HISTORIC AND DESIGN REVIEW COMMISSION

HDRC CASE NO: 2018-096
ADDRESS: 510 E GUENTHER ST
LEGAL DESCRIPTION: NCB 938 BLK 1 LOT 17 N 25 FT OF 16
ZONING: RM-4, HS
CITY COUNCIL DIST.: 1
DISTRICT: King William Historic District
LANDMARK: Raba Studio / Goldbeck House
APPLICANT: Jim McKissick
OWNER: Jim McKissick
APPLICATION RECEIVED: February 13, 2018
60-DAY REVIEW: April 14, 2018
REQUEST:

The applicant is requesting a Certificate of Appropriateness for approval to reconstruct a side porch.

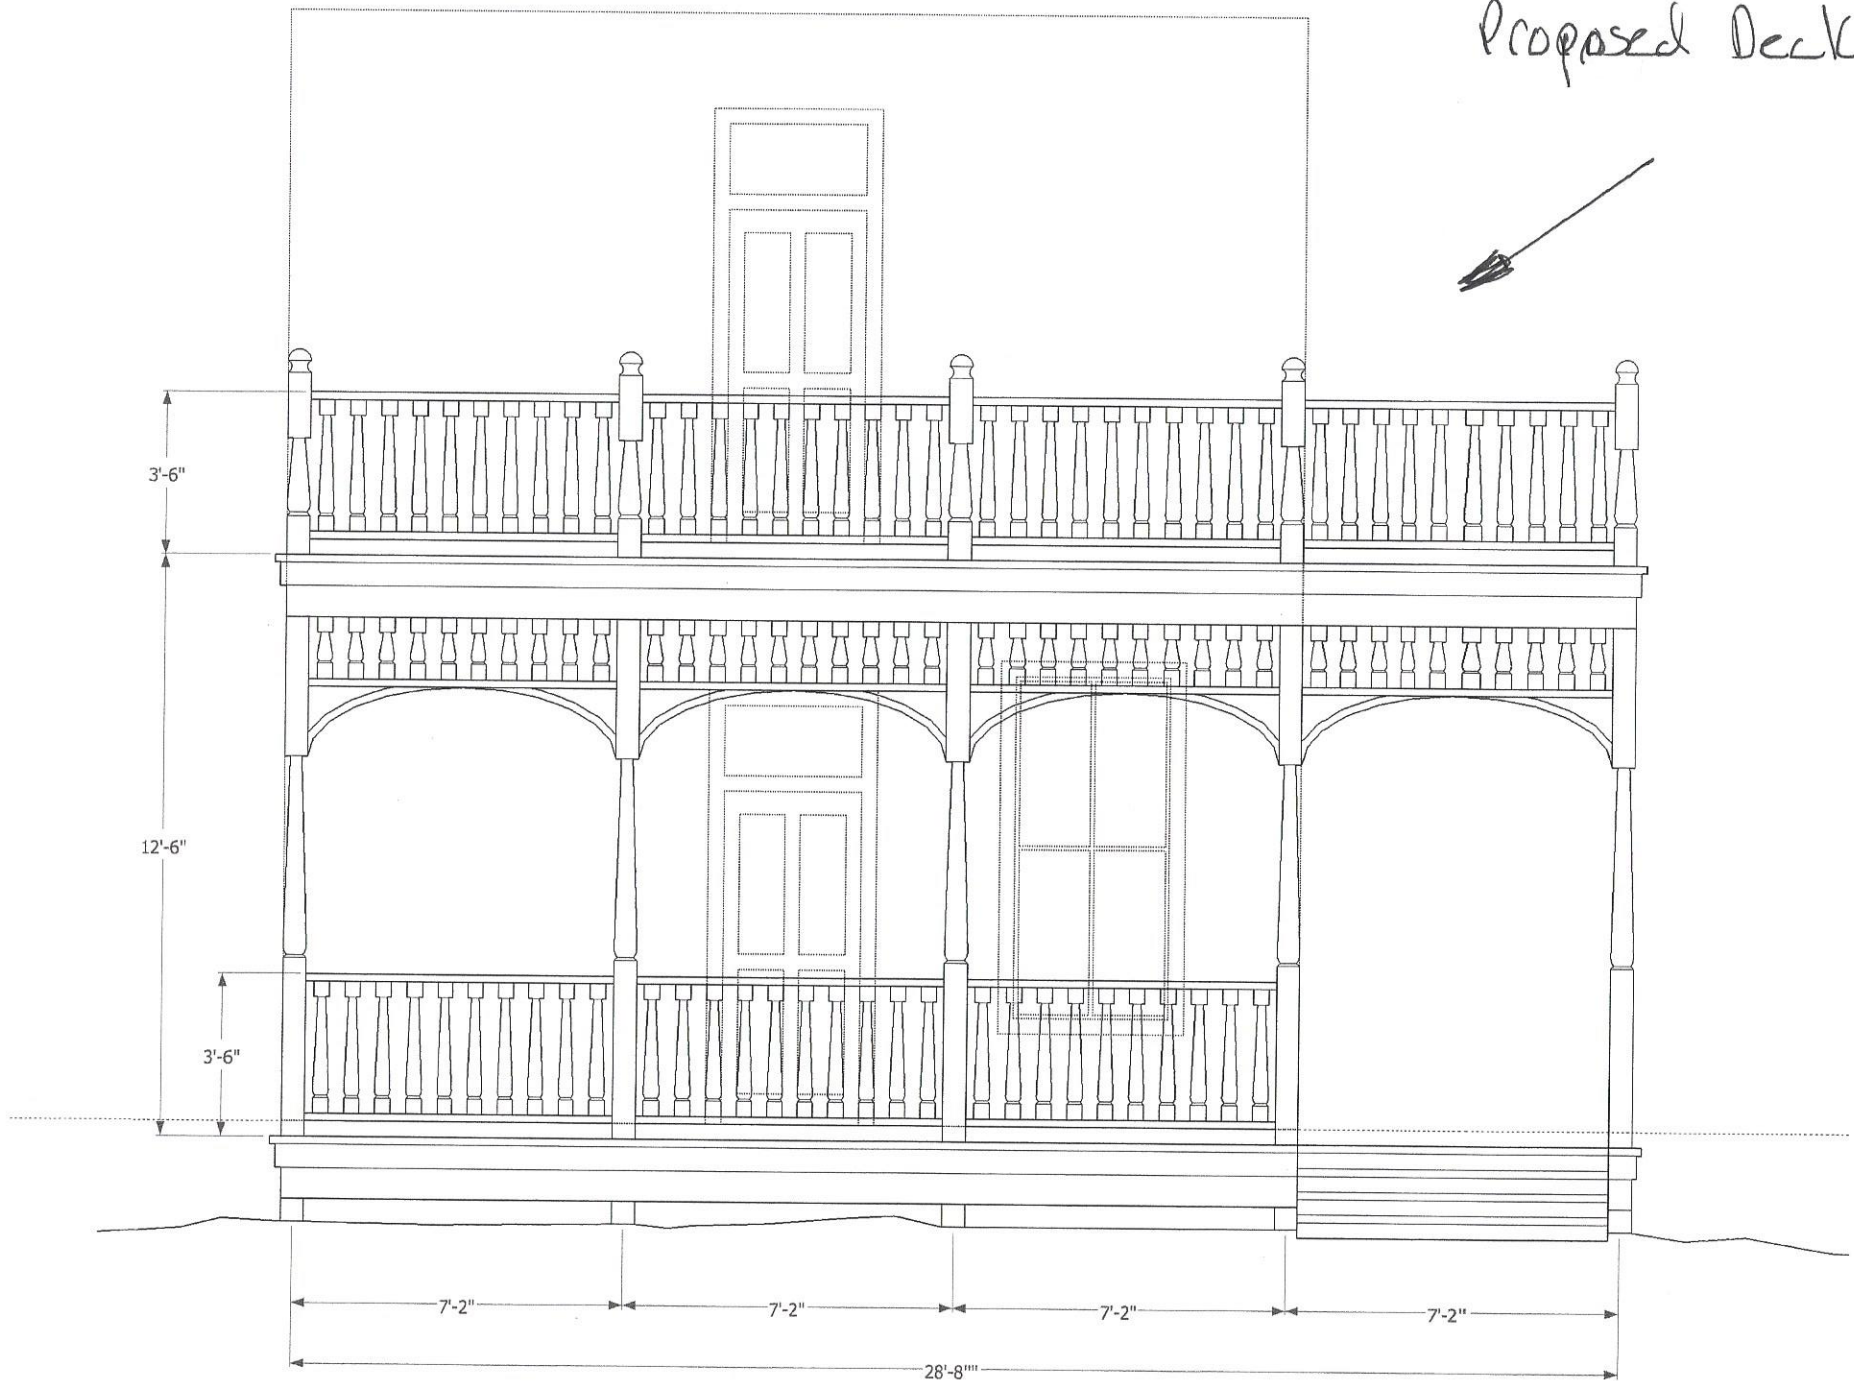
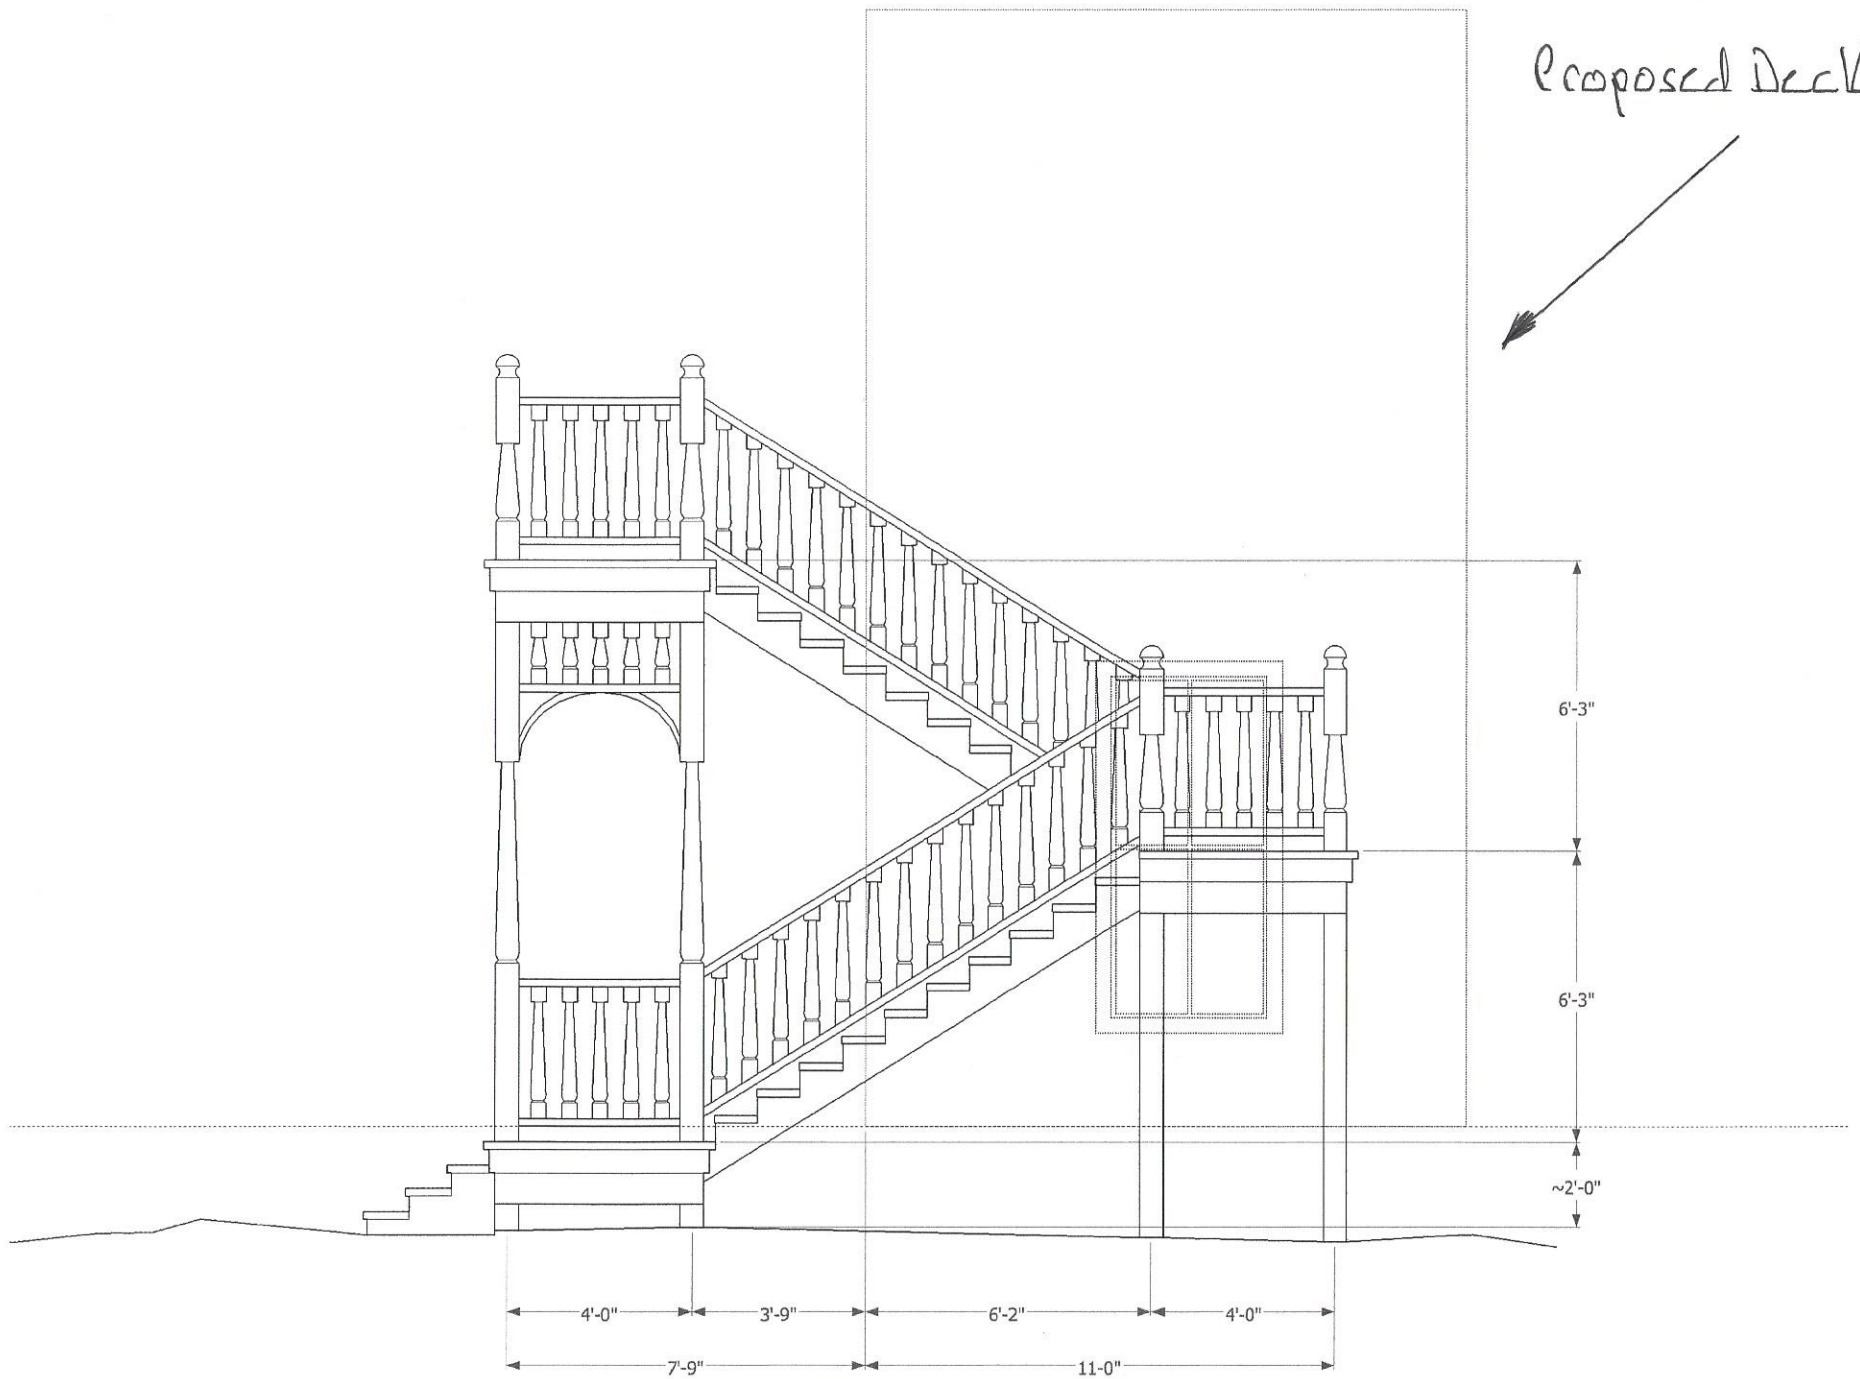
- a. The historic structure at 510 E Guenther was constructed circa 1895 in the Folk Victorian style and features an L-plan, hipped, gable and conical roofs. The structure, per the 1904 Sanborn Map and a historic photo, the structure originally featured a side, double height porch. At this time, the applicant has proposed to reconstruct this porch per the historic photo.

- b. PORCH RECONSTRUCTION – The Guidelines for Site Elements 7.B.v. notes that porches should be reconstructed based on accurate evidence of the original, such as photographs. The applicant has provided construction documents noting the reconstruction of the porch to be similarly constructed per the original. The applicant has included an addition bay to feature access stairs. Generally, staff finds the proposed porch to be appropriate and its reconstruction to be consistent with the Guidelines. The applicant has noted that all elements will match those found historically on the structure in material and profile.

Staff recommends approval as submitted based on findings a and b.
